# Strathfield Local Planning Panel Meeting

**Thursday, 2 August 2018**

**TO:** Strathfield Local Planning Panel Meeting - 2 August 2018  
**REPORT:** SLPP – Report No. 1  
**SUBJECT:** DA2018/076 - 76 WATER STREET, BELFIELD  
LOT S IN DP 394194  
**DA NO.** DA2018/076

**Proposal:** Demolition of existing structures and construction of infill affordable rental housing with basement parking and strata subdivision.

**Figure 5: Existing extent of overshadowing in winter solstice**

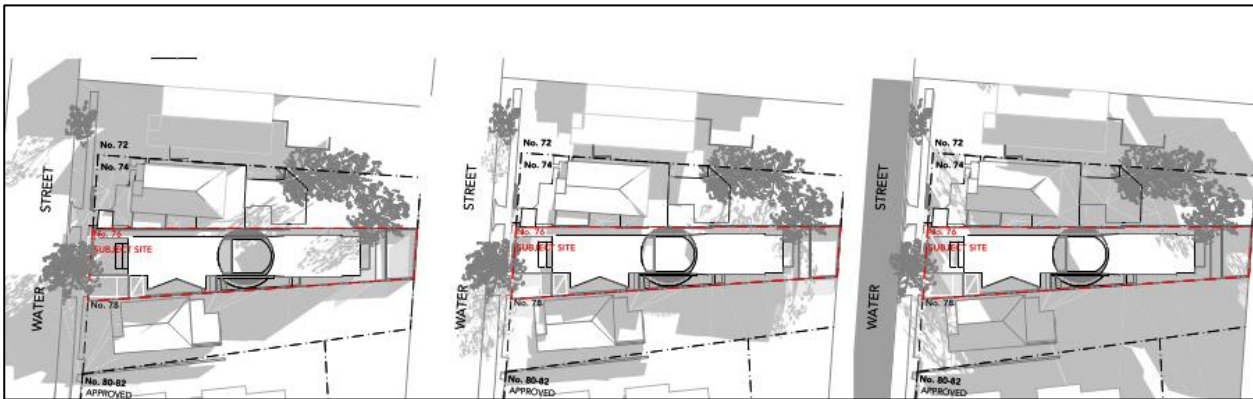
Section 3B – ‘Orientation’ of the Apartment Design Guide requires new development to be responsive to the streetscape and site, designed to optimise solar access and not to reduce solar access by more than 20%. Due to the relatively narrow width and east-west orientation of the site, overshadowing to the southern adjoining dwelling is inevitable. Based on the shadow diagrams submitted as part of the application (refer to figure 5 and 6 below), it appears that the northern side elevation and rear private open space areas of the southern adjoining dwelling are overshadowed by the existing dwelling on the subject site.

Based on the diagrams above, it appears that the southern adjoining dwelling will benefit from direct solar access to portions of the rear private open space areas between 9am – 12pm. Whilst it appears that by 3pm the entire rear portion of the site will be cast in shadow, the front elevation of the dwelling will receive almost direct solar access from 12pm-3pm. This will allow the dwelling to receive some direct solar access during the day.

**Figure 6: Photomontage of the proposed site frontage.**

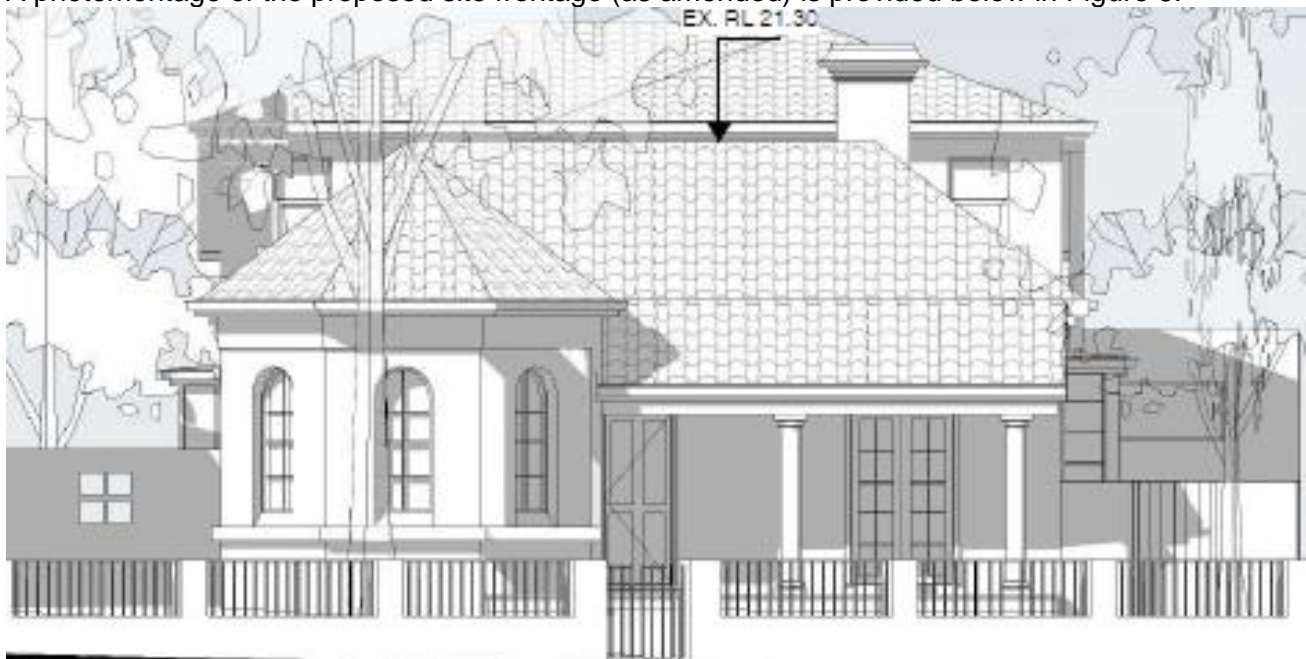
A photomontage of the proposed site frontage (as amended) is provided below in Figure 6.

Figure 11: The existing residential dwelling with the proposed rear addition (as amended)

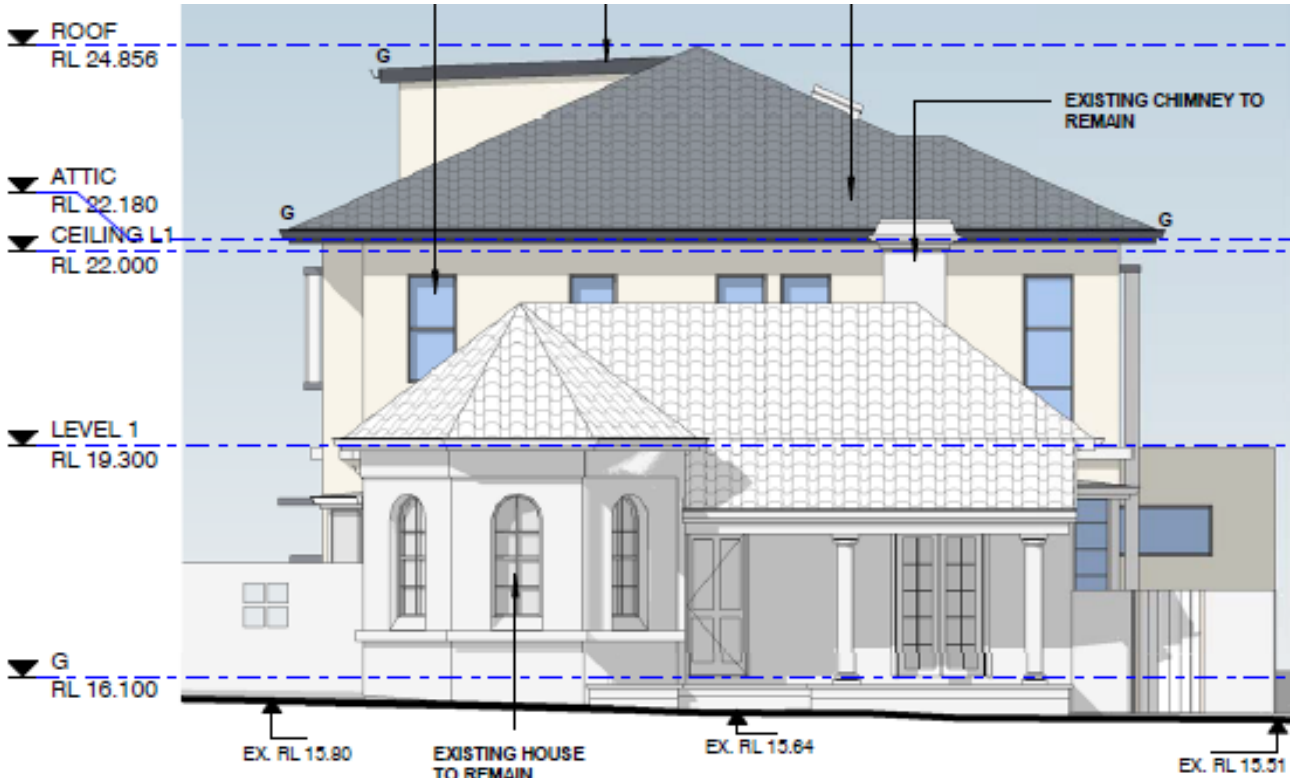
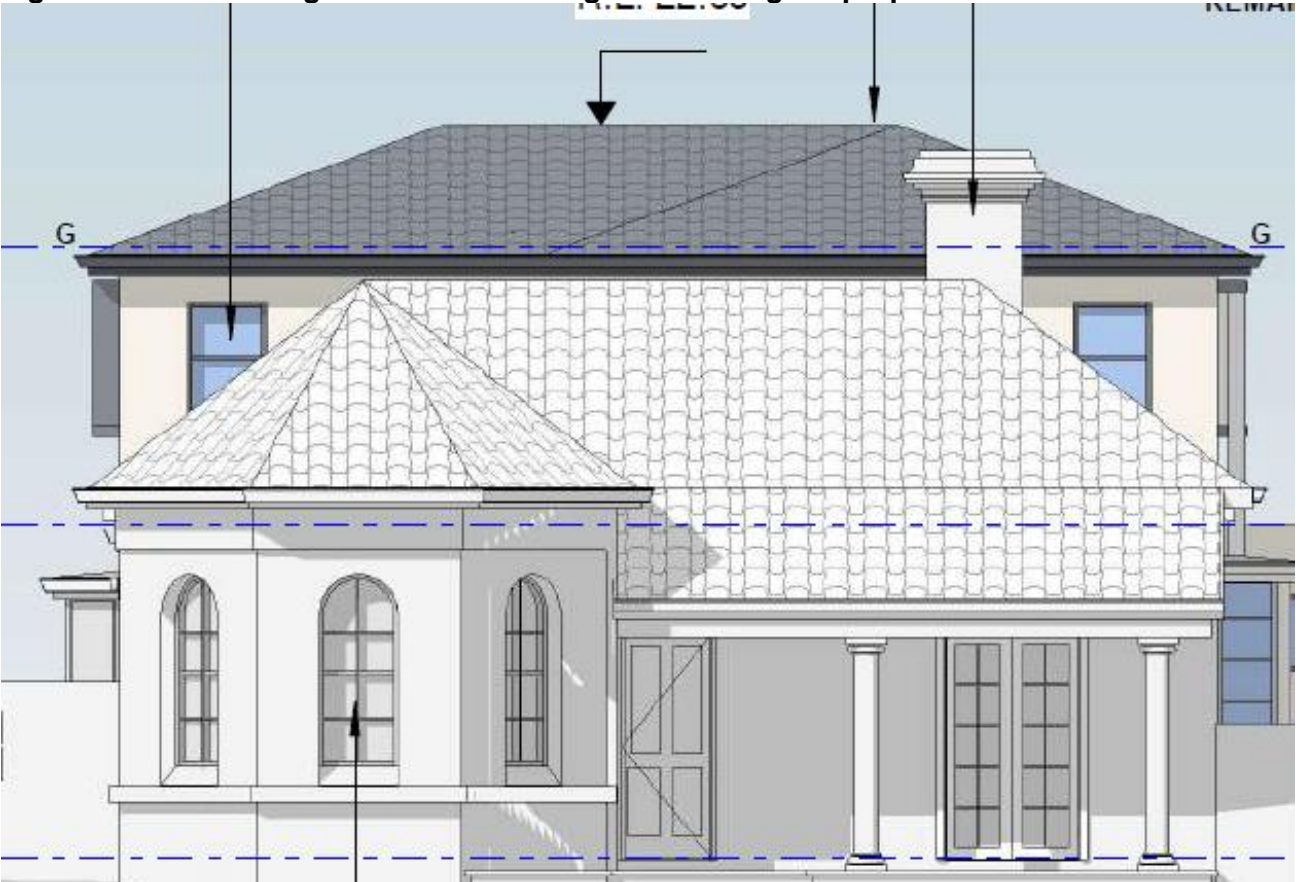
– Victorian Villa (Item I112), amended plans were required in order to demonstrate a more sympathetic design outcome to those unique built forms (Figure 9).

To reflect on this, amended plans were submitted to Council, which have demonstrated a reduction to the building height and floor space. As a result, this has formed a more sympathetic design outcome in that the overall bulk and scale apparent from the front setback will not result in detrimental impacts in terms of influencing the overall amenity of the area and potential view corridors for surrounding built forms (Figure 11).
